**Project:** VCSD 2024 Capital Project

**Add. No.:** Pre-Bid Addendum 003

*A d d e n d u m*

### 2 SECTION AT BASE OF GUARDRAIL

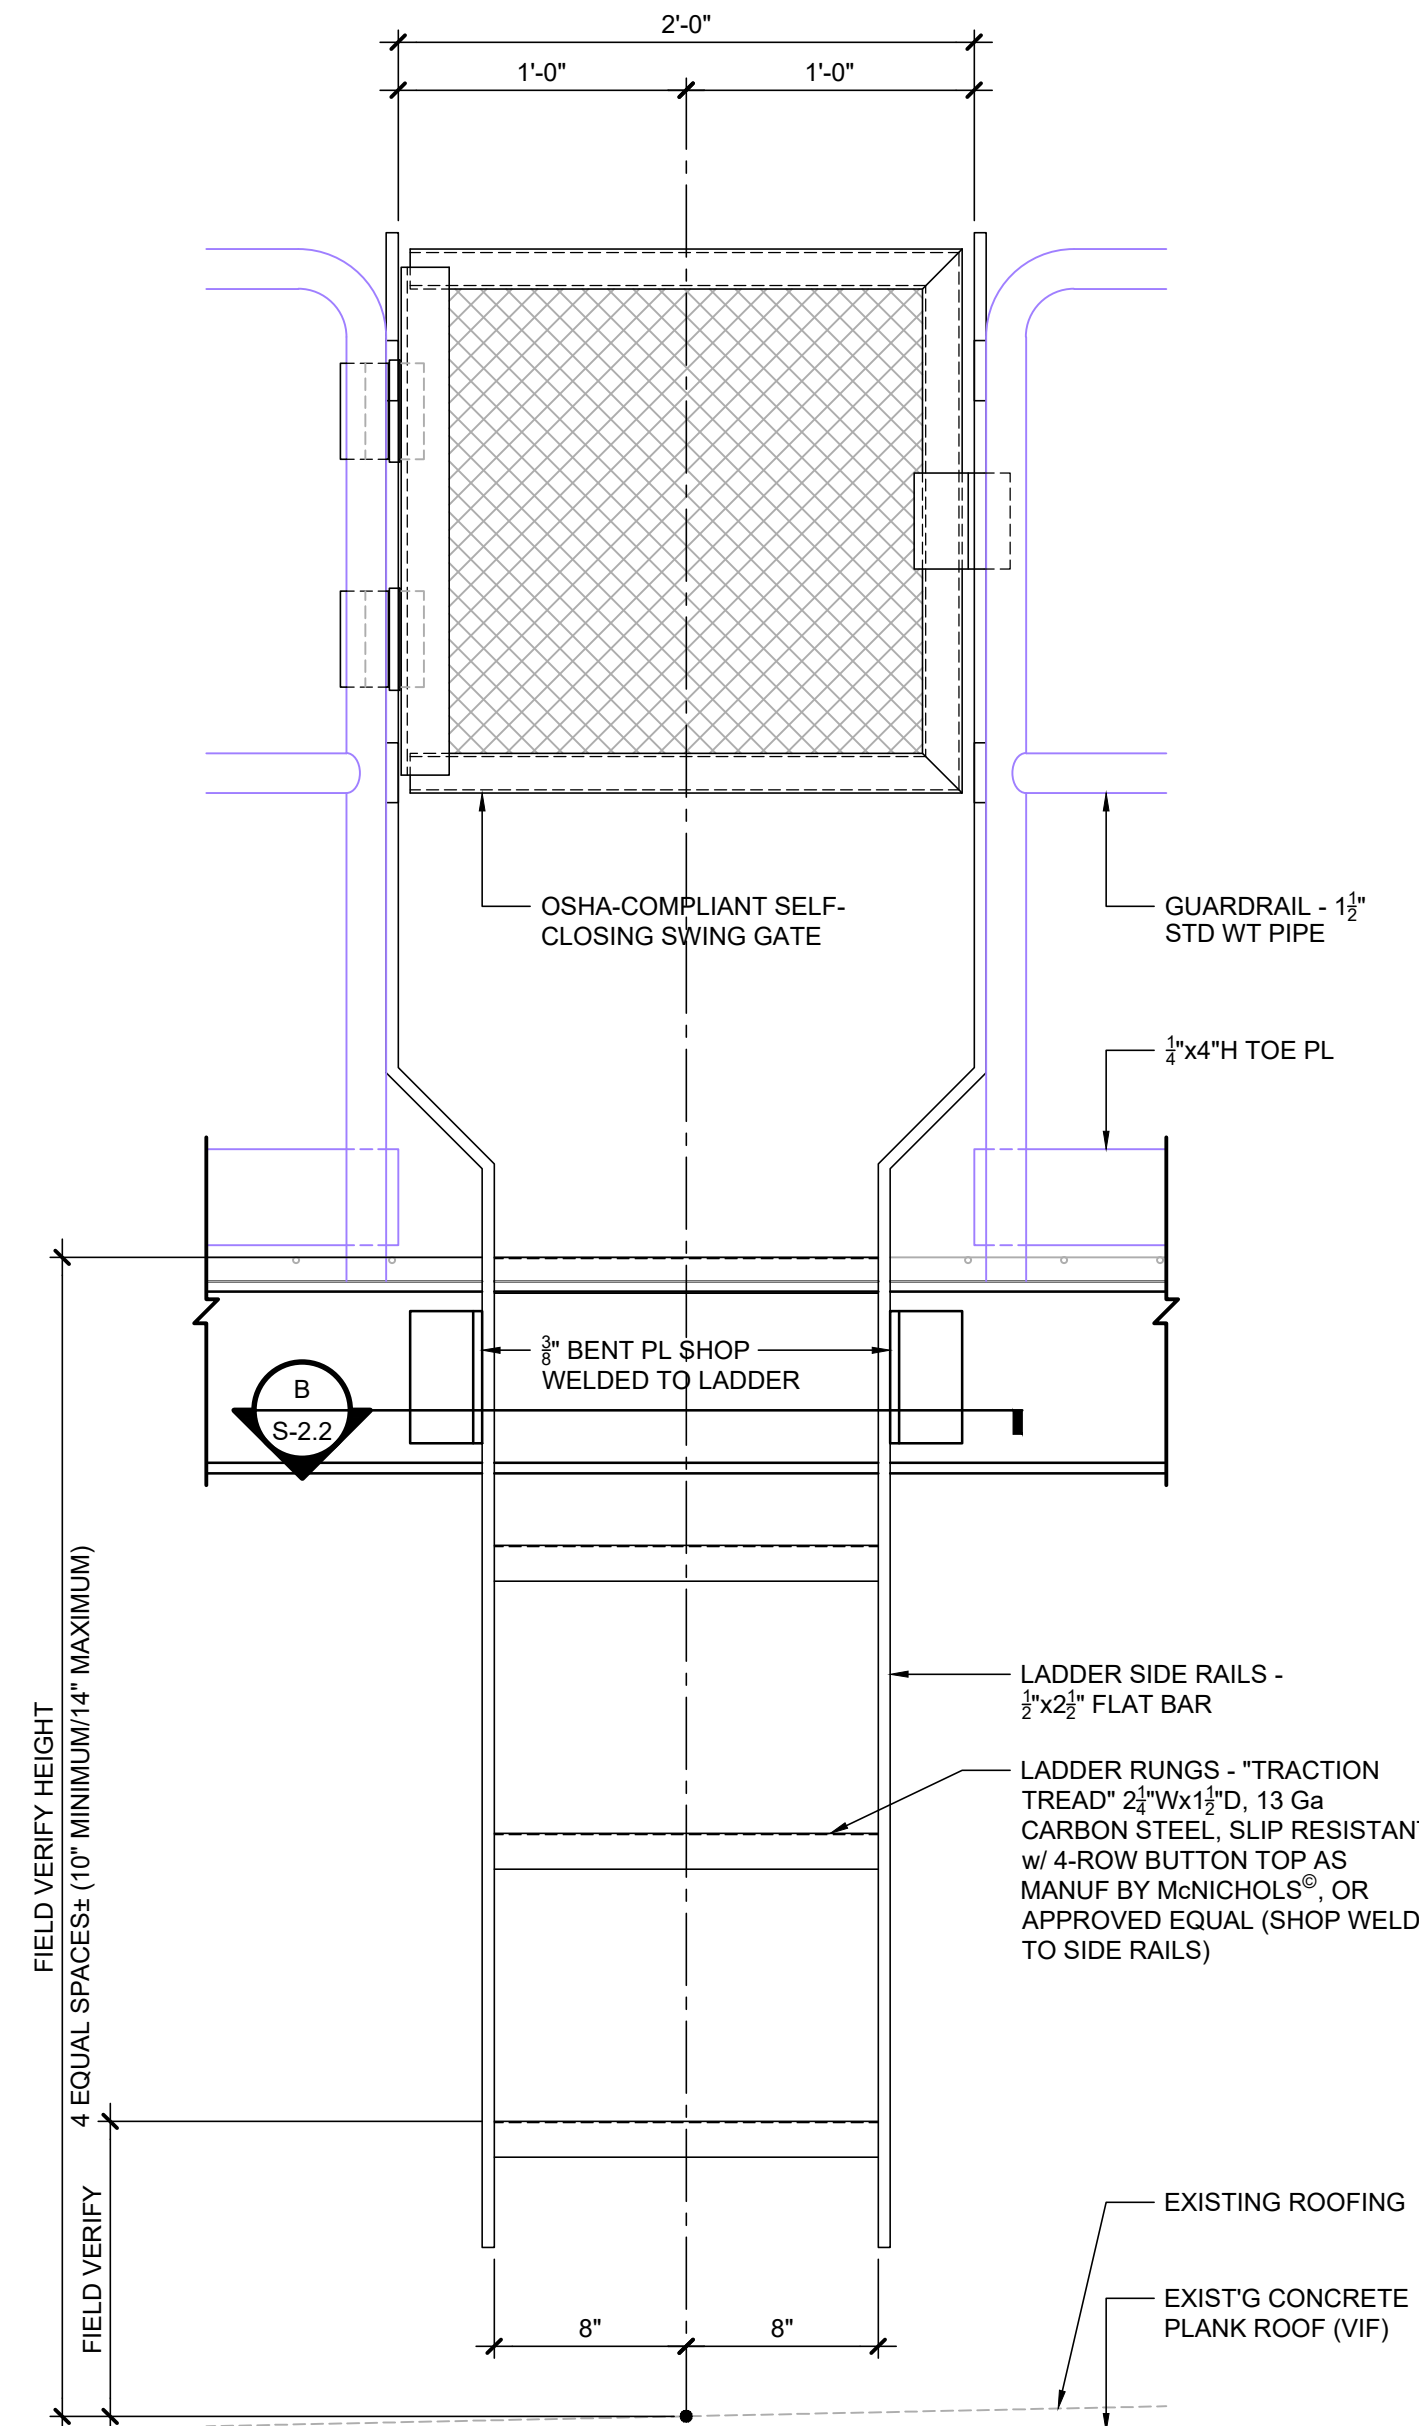
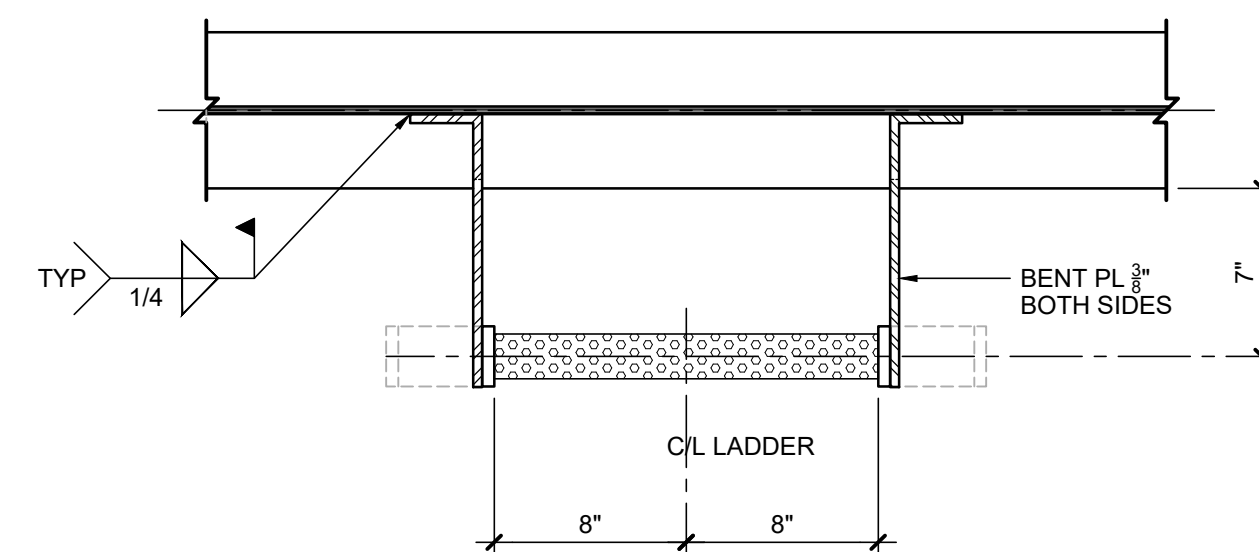
| PRE-BID ADDENDUM 003                                                          | 7/24/26 |
|-------------------------------------------------------------------------------|---------|
| • ADDED KEYS FOR DETAIL A/S-2.2 AND SECTION 2/S-2.2 TO<br>RTU DUNNAGE SECTION |         |
| • ADDED DETAILS A AND B/S-2.2 AND SECTION 2/S-2.2                             |         |
